LIVSEY & COMPANY, INC.
INDIANA & MICHIGAN ELECTRIC CO.
DONALD C. COOK NUCLEAR PLANT

DWN. SG DATE: 12-19-71 AUXILIARY BLDG
CKD. GN DATE: 1-6-72 DWG. NO. 2-NSW-105 SH. 2 of 2 REV. 8
ISSUED
REF. DWG. 2-5437.

2NSW-105 (sheet 2 of 2)
Upper Containment Ventilation
Unit 3 Supply Line

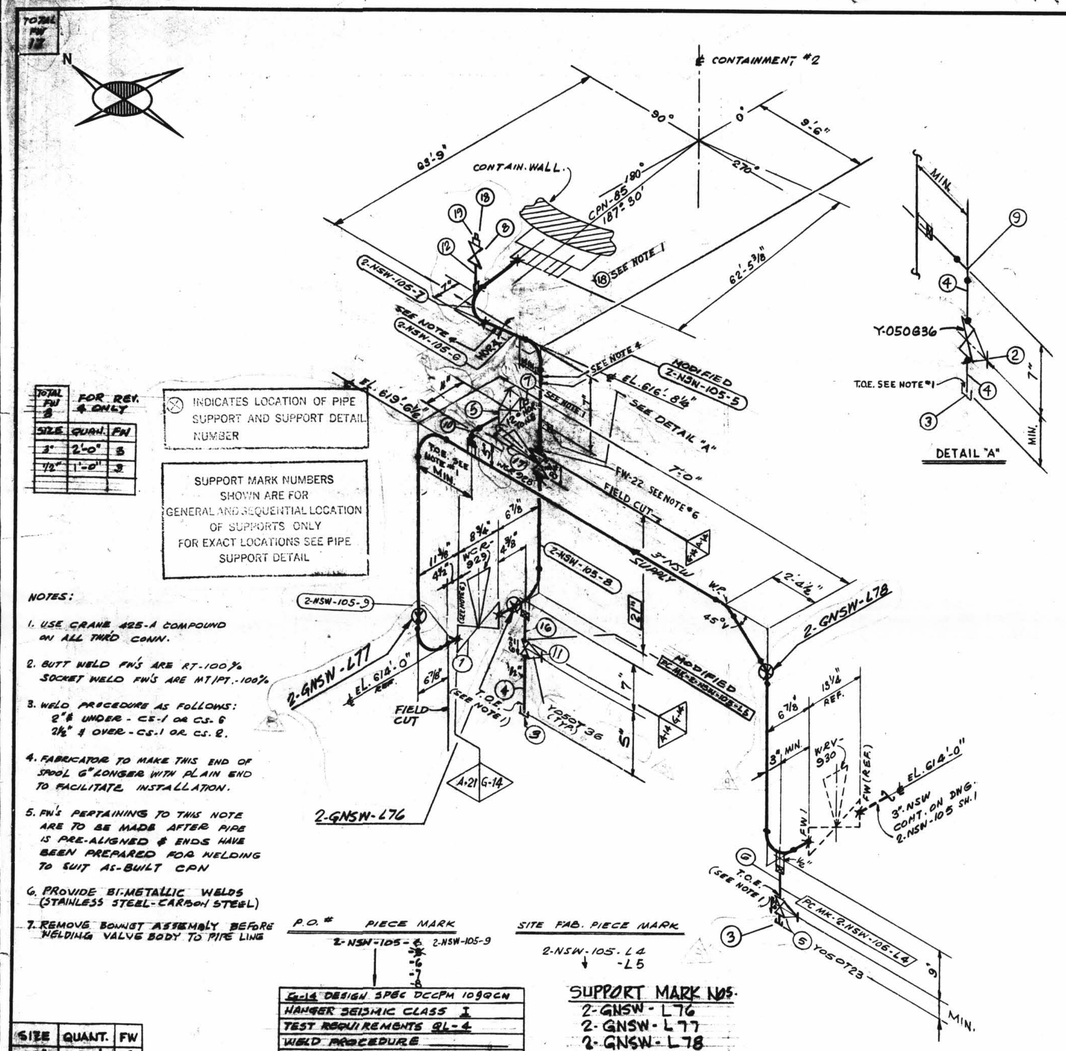
NO.	DATE	DR. CHKD	DESCRIPTION	REMARKS
1	1-20-76	DR BR	REVISED BY AEP DESIGN: PER RFC-12-671: REV'D; ITEM #2 Y-050G36 WAS CY-050G36; ADDED; 3" CHECK VALVE C15CE03A; (2) 1" VENTS - VALVE No Y-100T23, 1/2" DRAIN VALVE No Y-050G36.	ACTION REQ'D.
2	12-3-76	DR	ADDED: ITEMS 9, 10 & 11 TO B/M.	
3	3/1/78	GP LB	AS PER NRR-12-1930 DELETED VALVE TAG NO. C15CE03A, ADDED VALVE TAG NO. C15CW03A & ITEMS 12 THRU 15 AND REVISED RELATED PIPING	FIELD ACTION REQ'D
4	7/19/78	AG DR	PER RFC DC-12-2549 ADDED PIPE SPEC. G-16, DIM'S, PC MK 929, FIELD WELD BOM, NOTES 6 & 7, FW 18 TO 23, FSW 24 & 25, ITEMS 16 & 17 TO B/M. DELETED ITEMS No 7 & 12 TO 15 FROM B/M. REVISED ITEM No. 1 IN B/M MODIFIED, ADD K.L.S. 2-NSW-105-5.	FIELD ACTION REQ'D
5	10/14/78	RA JM	PER RFC DC-12-2549 ROTATED ACTUATOR OF VALVE WCR-928 TO 18° HOR. TOWARD NORTH-EAST, REVISED ITEM 5 IN B/M; Y-050T36 WAS Y-050T22.	FIELD ACTION REQ'D.
6	8/2/79	SG GG PF	PER RFC-DC-12-2549 RELOCATED TEST CONN. BOXED DIMENSION INDICATES FIELD INFO. ADDED PLUG TO ITEM 5 & 9M.	FIELD ACTION REQ'D.

7	10/1/79	WF JM	PER RFC-DC-12-2549 ADDED RED. INSERT, ITEM 19 & PLUG, ITEM 18, TO VALVE, ITEM 8. ITEM 8 WAS Y-100T23 & ITEM 18 WAS 1".	NO ACTION REQ'D.
8	7/12/80	EBB GSW LB	TO REFLECT AS-FOUND CONDITIONS FOR RFC-DC-12-3010 PER FWR # 759 REV. 1; ADDED: DIMS. REVISED: LOCATION OF 1" VENT, 1/2" DRAIN FROM PLUG TO CAP & B/M TO SUIT. ADDED: SUPPORT MARK NOS. & SUPERSEDES HGR. ISO. NO. 2-GNSW-105 SH. # 2.	NO FIELD ACTION REQ'D.
